Our Ref: 2219_TPA16

Property Address: 197-201 Teviot Road, Greenbank
Subject: Traffic Statement – Response to Outstanding Issues

We refer to the correspondence issued by Economic Development Queensland (EDQ) dated 9 February 2026 outlining outstanding matters associated with the proposed subdivision.

Figure 1: Landscape Islands

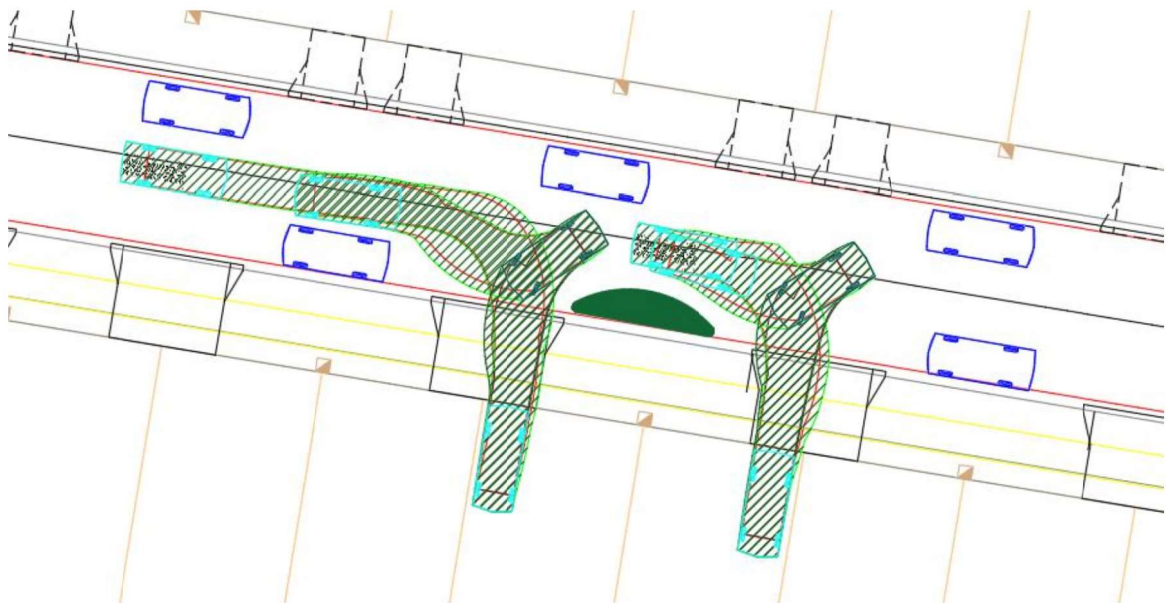
Landscape build-outs

The design incorporates two (2) landscape build-outs, as shown in **Figure 1**. These build-outs result in the removal of two (2) kerbside parking spaces; however, this is considered appropriate in the context of the overall parking provision across the site. The build-outs provide traffic calming benefits by narrowing the perceived carriageway width and assisting to moderate vehicle speeds, while also contributing positively to the streetscape through increased landscaping and visual amenity.

Figure 2: Driveway Locations

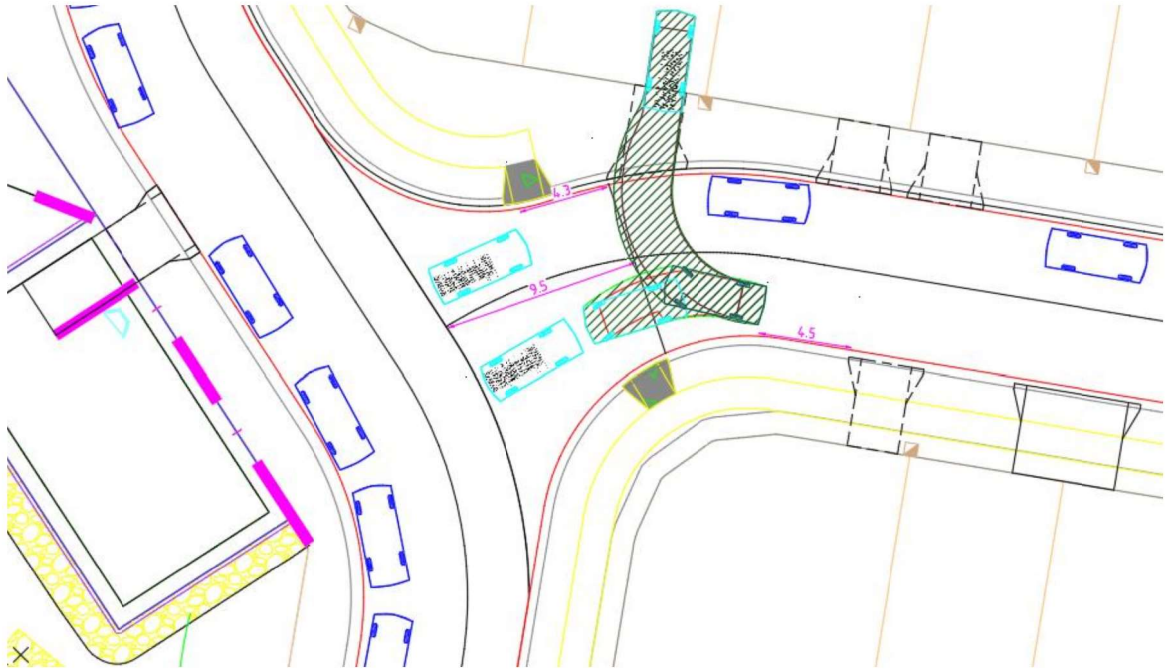
Driveway locations

It is acknowledged that AS/NZS 2890.1 nominates a desirable driveway offset of 6 metres from the tangent point of the kerb at an intersection. As shown in **Figure 2** below, the proposed access points achieve an offset of approximately 4.3 to 4.5 metres and therefore represent a minor variation to this criterion. In our opinion, this variation is acceptable. Due to the generous kerb return, the practical separation between the driveways and the intersection is approximately 9.5 metres, which is the more relevant measure from an operational perspective. This clearance is sufficient to ensure that standing or turning vehicles associated with the intersection would not impede driveway access, and vice versa. In addition, the intersection is located within a low-speed residential environment and provides good sight distance for vehicles entering and leaving the subject driveways. Accordingly, the proposed access arrangement is considered to remain safe and functional notwithstanding the minor departure from the nominal AS/NZS 2890.1 dimension

Bin Presentation Plan and Refuse Vehicle Swept Path Assessment

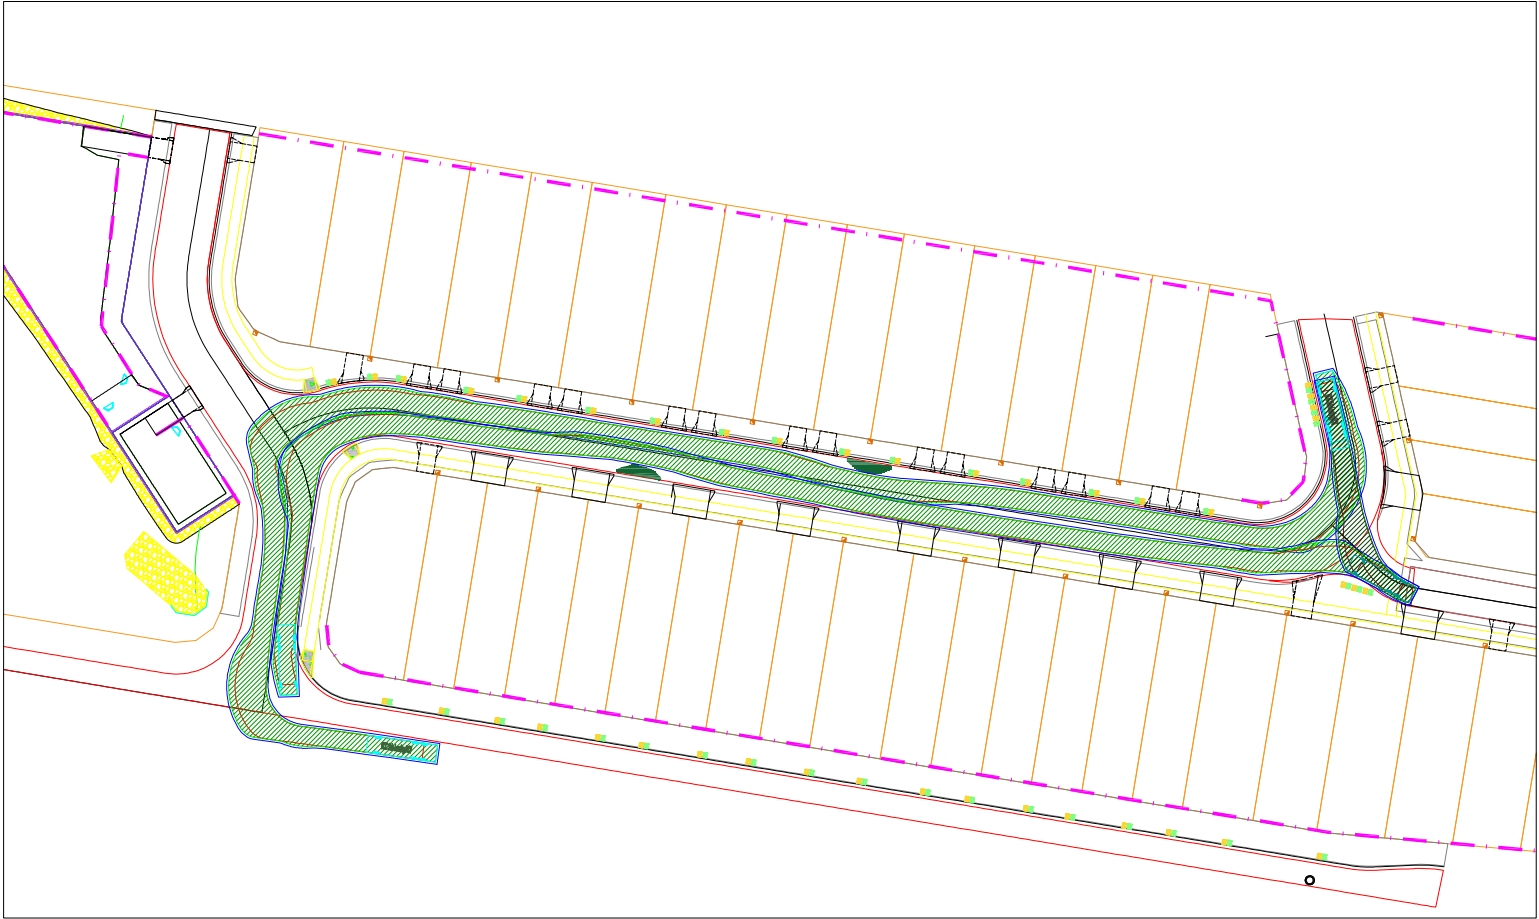
Item 1g – Bin presentation and waste collection

In response to EDQ's comments, the waste management arrangement has been revised.

- Updated bin presentation locations; and
- A swept path assessment demonstrating the manoeuvring of a side-loading refuse collection vehicle.

- The previously proposed bin pad adjacent Lot 36 (servicing approximately 10 dwellings) has been removed and relocated;
- Lots 1–16 and 40–42 are able to present bins to either Leanne Court or the new road. For the purposes of assessment, bin presentation for these lots has been shown to Leanne Court as this frontage is less constrained, however either frontage is considered acceptable from a servicing perspective;
- The layout has been refined such that the refuse vehicle can service all dwellings with only a single three-point turn required at the stub road.

On-Street Parking Plan

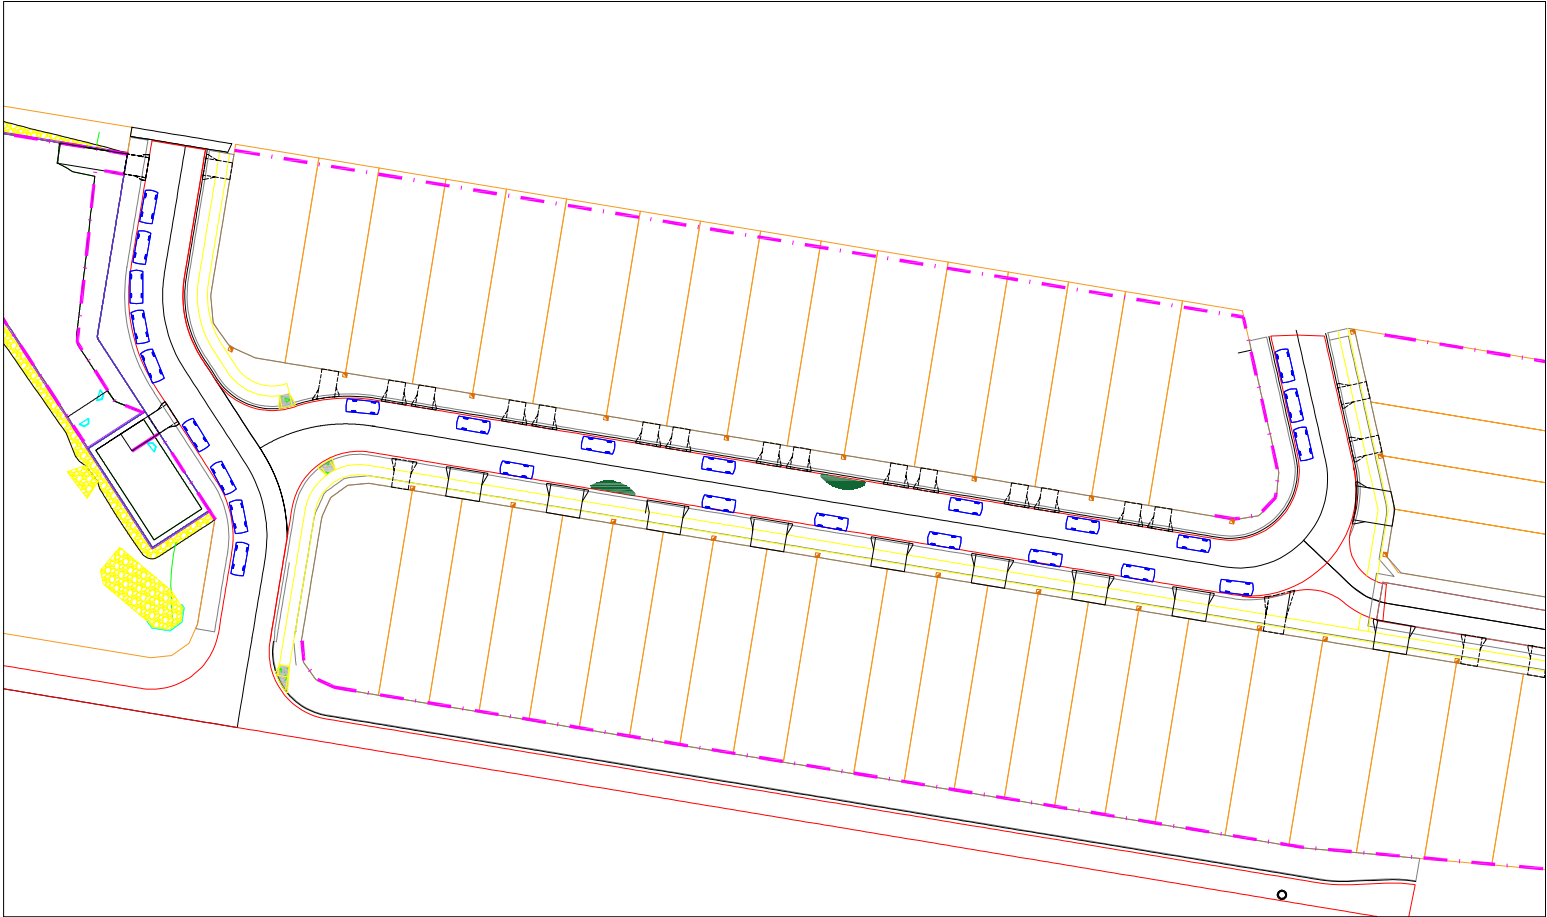
On-street parking

Reference is made to PDA Guideline No. 05, which seeks an outcome of **0.75 on-street parking spaces per dwelling**.

An updated on-street parking plan has been prepared (refer Attachment 3), which demonstrates:

- A total of 26 on-street parking spaces;
- Supporting 42 residential lots; and
- An equivalent provision of approximately **0.62 spaces per lot**.

The first kerbside parking space on the new north-south road is located approximately 18 metres from its intersection with Leanne Court. This comfortably exceeds the minimum 10 metre no-stopping requirement applicable to an unsignalised intersection under the Queensland Road Rules and provides adequate clearance for vehicle manoeuvring in the vicinity of the intersection.

While this is marginally below the 0.75 spaces per lot target, the extent of variation is considered acceptable having regard to the following:

Lots fronting Leanne Court have pedestrian access to this frontage. Whilst not relied upon for compliance, this frontage provides additional kerbside parking for up to 15 vehicles should it be required.
